గ్రాంత్ర	20					
Form 3160+5 (August 2007) DE	united States PARTMENT OF THE INTERIOR		HOB3		FORM APPROVED OMB No. 1004-0137 Expires: July 31, 2010		
	REAU OF LAND MANAGEMEN		JUL 1	5. Dease Serial No. NMNM105885			
	NOTICES AND REPORTS ON			6. If Indian, Allottee	or Tribe Name		
	form for proposals to drill or t Use Form 3160-3 (APD) for st						
SUBM.	IT IN TRIPLICATE – Other instructions	on page 2.			reement, Name and/or No.		
Oil Well Gas V	Well 🔲 Other		Ĩ	8. Well Name and N Perseus 10 Feder	al Com 4H

2. Name of Operator Chevron Operating Inc				9. API Well No. 30-005-29204			
3a. Address 1400 Smith St 43.076 Houston, TX 77002	832-714-06	o. (include area code 70		10. Field and Pool of Undesignated-AB	O-Wolfcamp

Perseus 10 Federal Com 4H 30-005-29204 Chevron Operating Inc. July 6, 2013

CONDITIONS OF APPROVAL

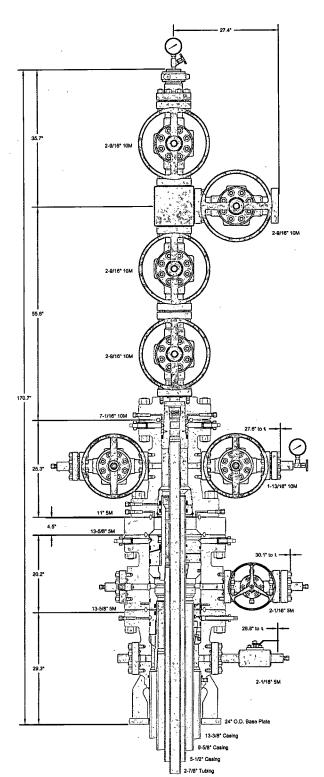
1. Operator has proposed a multi-bowl wellhead assembly. This assembly will only be tested when installed on the surface casing. Minimum working pressure of the blowout preventer (BOP) and related equipment (BOPE) required for drilling below the surface casing shoe shall be 3000 (3M) psi.

a. Wellhead shall be installed by manufacturer's representatives, submit documentation with subsequent sundry.

b. If the welding is performed by a third party, the manufacturer's representative shall monitor the temperature to verify that it does not exceed the maximum temperature of the seal.

c. Manufacturer representative shall install the test plug for the initial BOP test. Pressure test shall be low pressure then high pressure.

d. Operator shall perform the 9-5/8" and 5-1/2" casing integrity tests to 70% of the casing burst. This will test the multi-bowl seals.

e. If the cement does not circulate and one inch operations would have been possible with a standard wellhead, the well head shall be cut off, cementing operations performed and another wellhead installed.
